April 15, 2015

Re: Proposed Hydro-Electric Generating Station at the Bala Falls

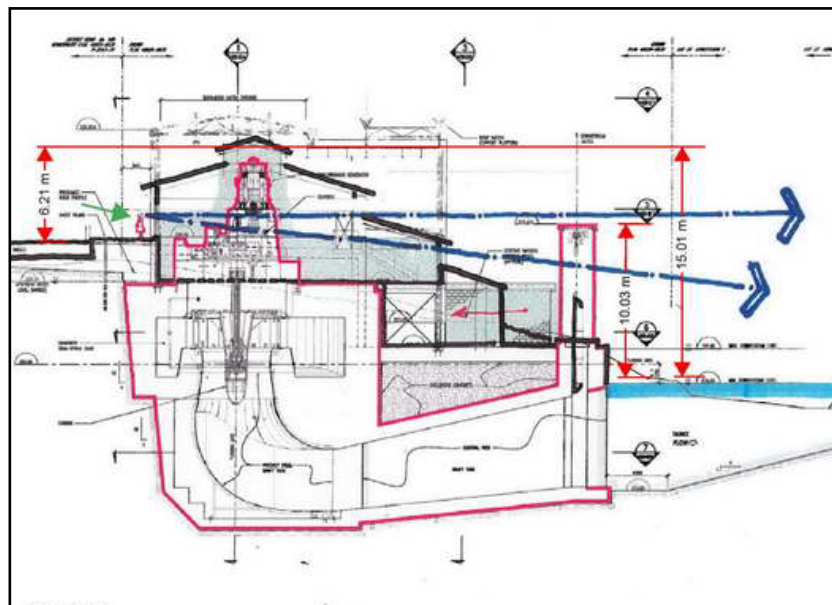
While the cross-section drawing (portion shown below, dimensions added) shown by your architect Karl Stevens at the December 16, 2014 meeting of the Township of Muskoka Lakes Committee of the Whole showed a building with a top of roof that would be 8.4 m (original drawing) or 6.9 m (Karl's rendering) above Muskoka Road 169, I understand you have recently informed the Bala Falls Hydro Project Working Committee that the roof would be 6.2 m above the road. The roof would therefore be approximately 15 m (49') above the Moon River.

I note that pdf page 29 of the Appendices of your 2012 Addendum showed that the roof of your Option 2 would be 16.6' above the Moon River, and your current Alternative 1A (taller as required by the vertical turbine, as noted in Addendum Sections 4.6.1, 6.2.2, and 6.2.3) would be 30' above the Moon River.

Could you explain this discrepancy that your 2012 Addendum showed the roof of your Alternative 1A structure, including vertical turbine, would be only 30' above the Moon River, yet your information recently provided show the roof would be at least 49' above the Moon River, as this certainly does appear to be a change to the project.
